**RE: Presbyterian Hospital Tower Expansion  
1100 Central Ave. SE  
Drainage Management Plan Stamp Date: 8/19/20  
Hydrology File: K15D005H**

Based on the submittal received on 8/20/20 and payment-in-lieu receipt on 9/22/20 the above-referenced Drainage Management Plan is approved for Building Permit and SO-19.

Re: Presbyterian Healthcare Services Hospital Tower – Hydrology Resubmittal:  
Hydrology File: K15D005H

PROPOSED DRAINAGE MANAGEMENT PLAN

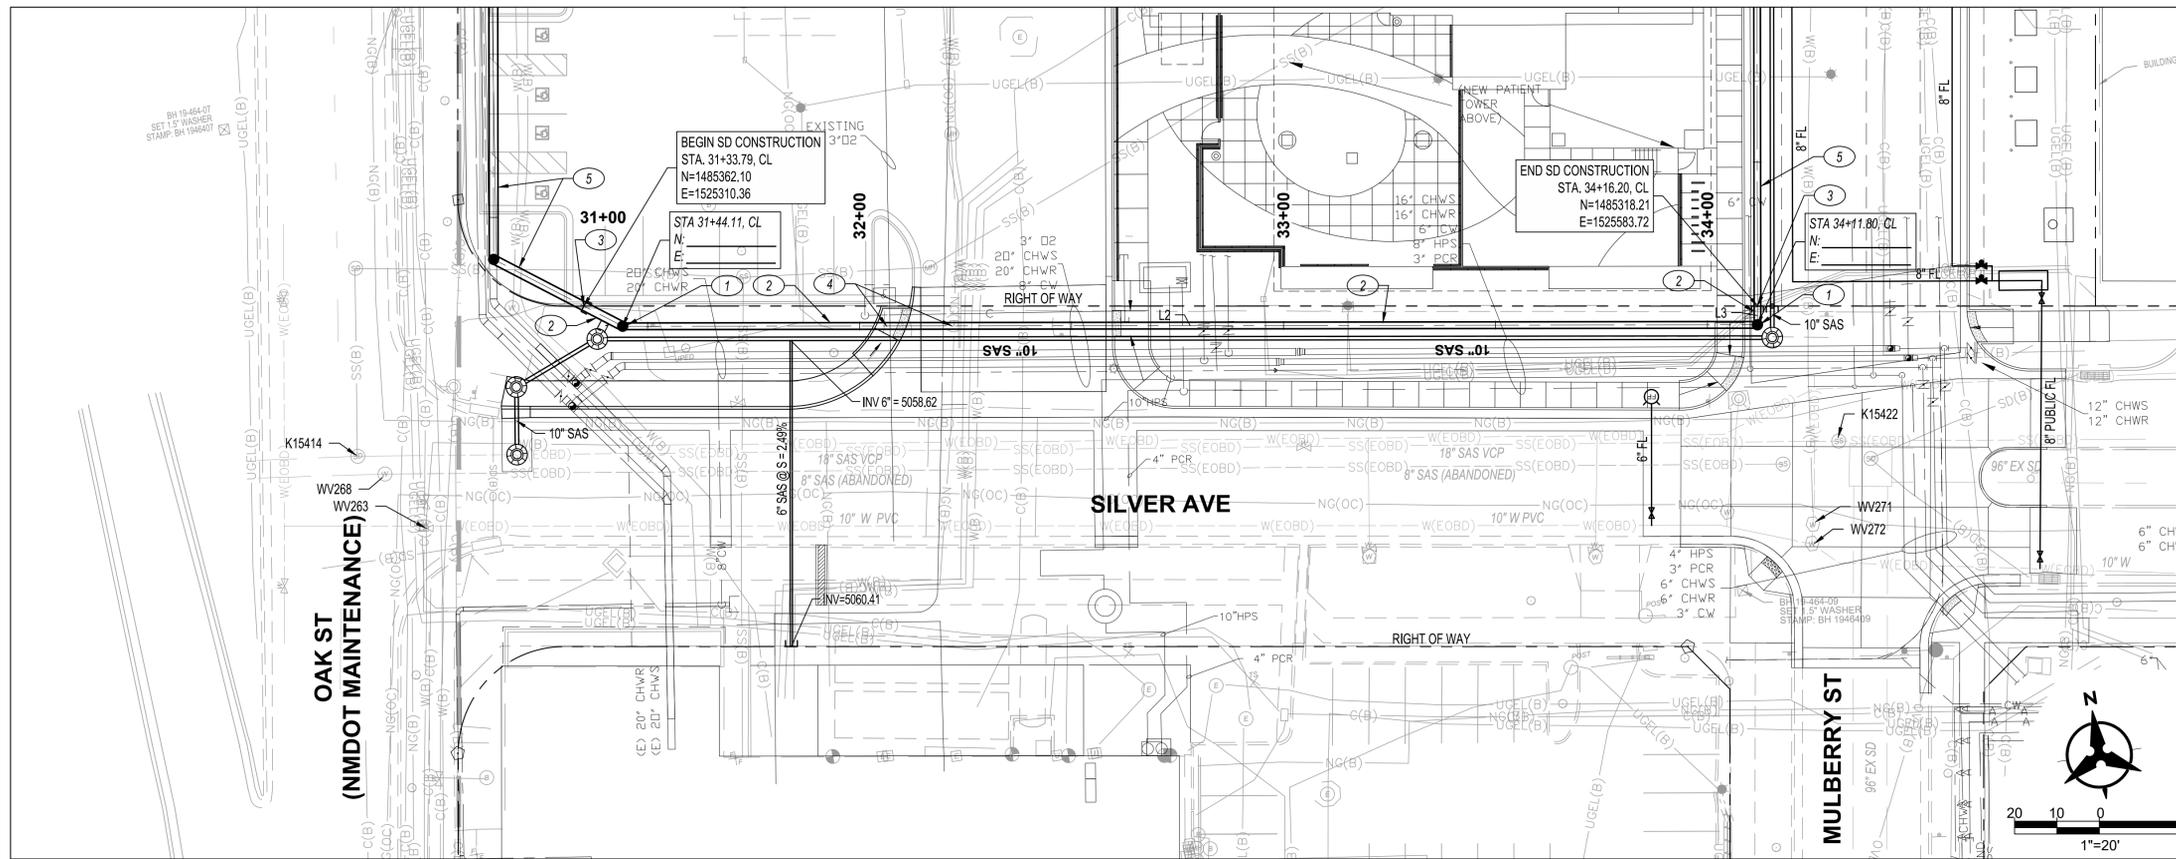
1. On the Drainage Management Plan sheet, it shows a  $Q=12.5$  cfs overflowing the inlet into Oak. The cumulative  $Q$  for Basins B1, B2 and B3 are 12.6 cfs.

6. Please provide the weir calculations, per DPM Chapter 22.3.A.1, for the sidewalk culverts. A coefficient of 2.7 is typically used for the weir equation  $Q = CLH^{2/3}$ .

*Response: This has been corrected*

*Response: A weir calculation was included. The table was labeled "concrete rundown". A weir coefficient of 2.65 was used. The calculation was updated to use 2.7. This minor change did not impact the required weir width.*

DRAWING NAME  
**STORM DRAIN PLAN  
& PROFILE**

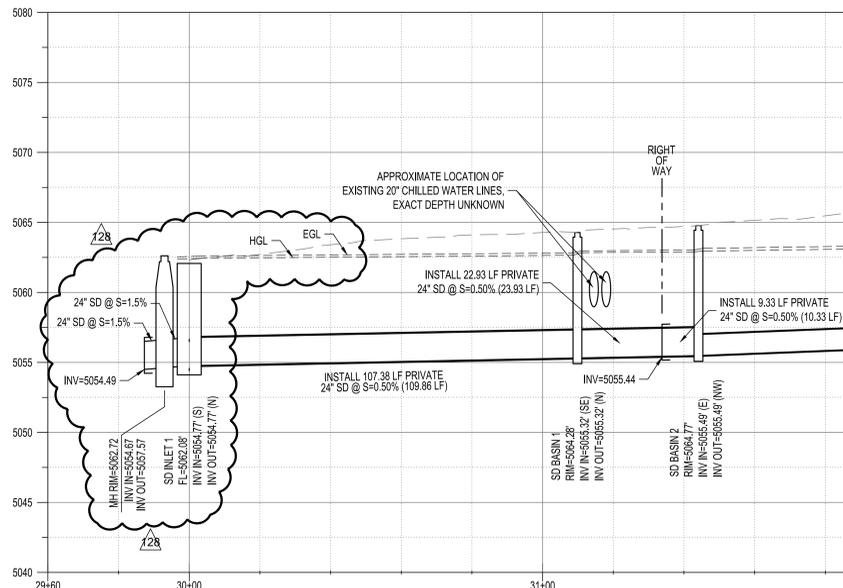
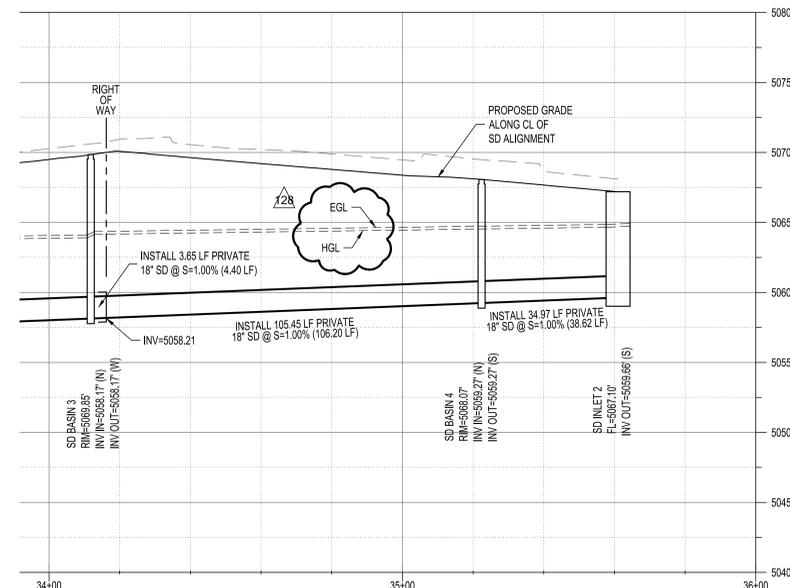
3. List the length of pipe for each section of storm drain.

4. Provide a profile of the storm drain system showing each bend in the system and show both the HGL and EGL in the profile.

5. Because this system is designed to outlet by overflowing the final inlet this system will be constantly full of water and will be prone to clogging. When the storm drain reaches Silver, starting at the 90 degree bend till it reaches the overflow inlet; it does not show what is happening at the bends. Are there manholes, inlets or cleanouts at these locations?

*Response: This storm drain was included with the site utility infrastructure package. The intent of the utility package was to prepare the site in advance of the hospital tower construction. This utility package was submitted and approved, but it appears hydrology was not in the review loop. The current storm drain plan is attached. This plan shows the length of each storm drain section*

*Response: HGL and EGL have been added to the profiles as requested*

*Response: You are correct that the drain line will hold water. This is an interim condition. The next phase of the hospital tower (west of the current project) will extend the storm drain north and connect to the public storm drain system in Oak*

*and the alignment of Gold. This work is being deferred until the next phase because of the extensive utility relocation necessary to install the storm drain. This line will be in Oak St right of way and understand approval from NMDOT will be required. Nyloplast drain basins are noted at the bends for maintenance access. We have added an interim sump pump and manhole at the downstream end of the storm drain system.*

REVISIONS (OR CHANGE NOTICES)  
**NEW MEXICO DEPARTMENT OF TRANSPORTATION**  
**PRESBYTERIAN HOSPITAL DRIVEWAY PERMIT PAVING & GRADING PLAN**

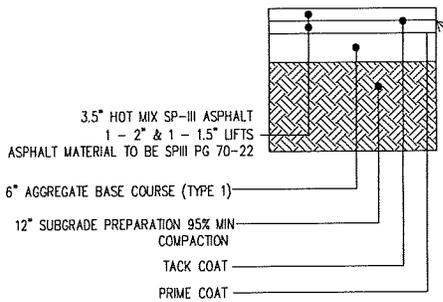
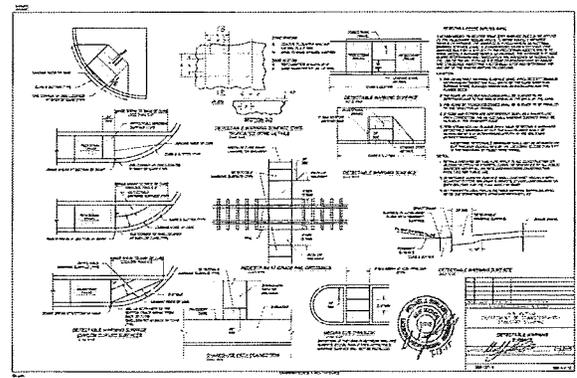
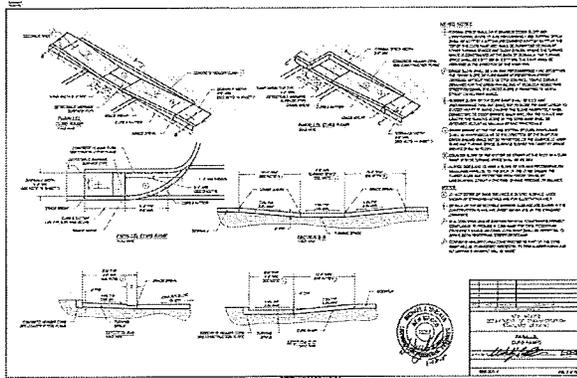
On driveway detail provide the following:  
 1) access width of 35 feet  
 2) curb return radius.  
 3) concrete valley gutter running across access driveway connecting the gutter?  
 4) Stop sign 36X36  
 5) Stop Bar 24 Inch Adjust note 7  
 6) Right of way depth from shoulder stripe/gutter. also indicate ROW on profile  
 7) Provide a key note indicating corner clearance from Central and Silver Ave to Center Line of Access  
 8) Identify grade break at ROW line as to prevent discharge into State ROW
